Historical Compatibility Assessment

Project: Main and Ninth streets, Riverside CA: proposed new mixed-use construction

Subject: Design and Material Compatibility Review Assessment

Site Context plan drawing

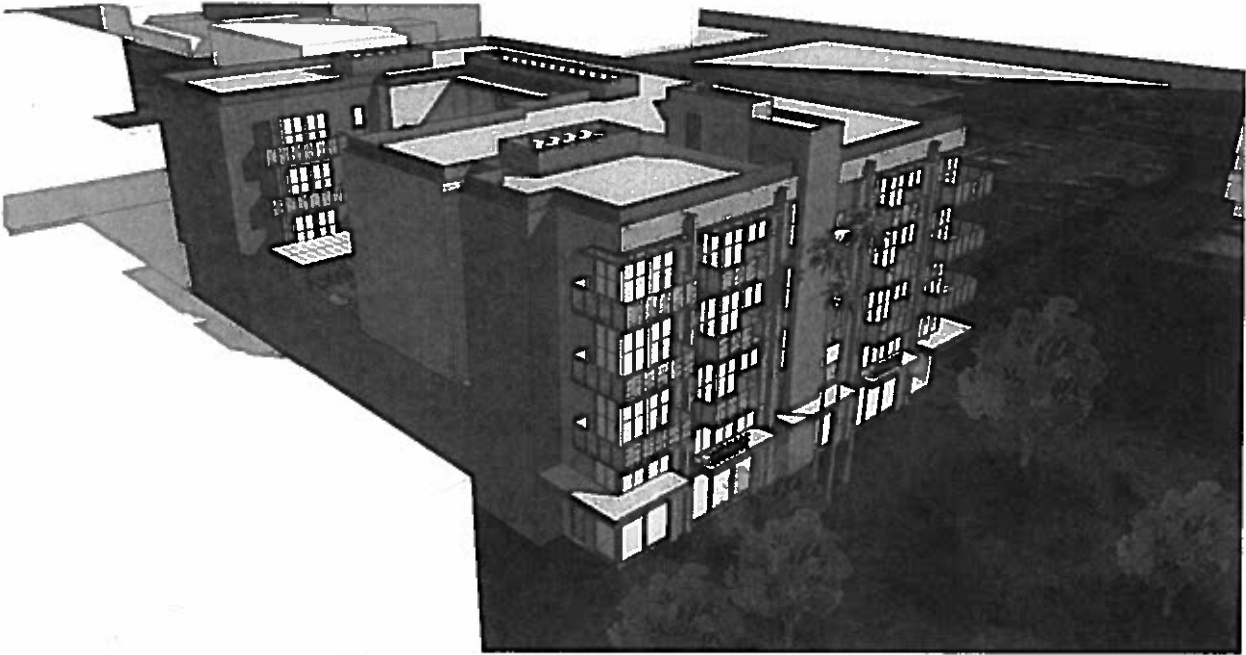
The property at the northeast corner of Main Street and Ninth Street is located within the Mission Inn Historic District. Architects Design Arc have developed a scheme for the corner of Main and Ninth that appears to meet a precedent idea of compatibility with the intentions of Riverside's Downtown Specific Plan and the client's building design precedent suggestions. This design performs well in the context south of Ninth street- mediating between the local Historic Landmark No. 73 Rouse Building (hereafter, UC Riverside's Culver Center for the Arts) to the north, and the massive City Hall structure to the south. Given the Ninth street corridor is located along the boundary of the Mission Inn Historic District, the proposed design mediates this interface between districts.

This structure is considered an edge structure, connecting differing scales and architectural design emphases.

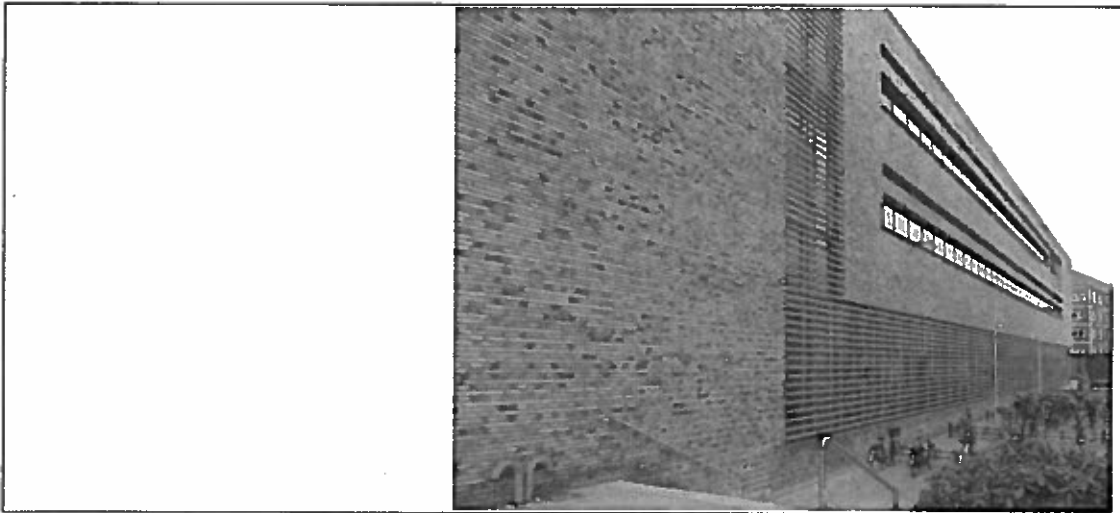
The proposed façade has distinctive layout configurations on each of four orientations in support of a U-shape structure in plan. The open end of the courtyard U shape faces north to the secondary façade of the Rouse Building. Vertical and horizontal themes are balanced between balconies interrupted by

masonry pier elements which terminate at the cornice level. In this revised scheme, the cornice line is held back from the façade, slightly stepped back in a reference to an Art-Deco-Moderne stylistic influence present elsewhere in Riverside.
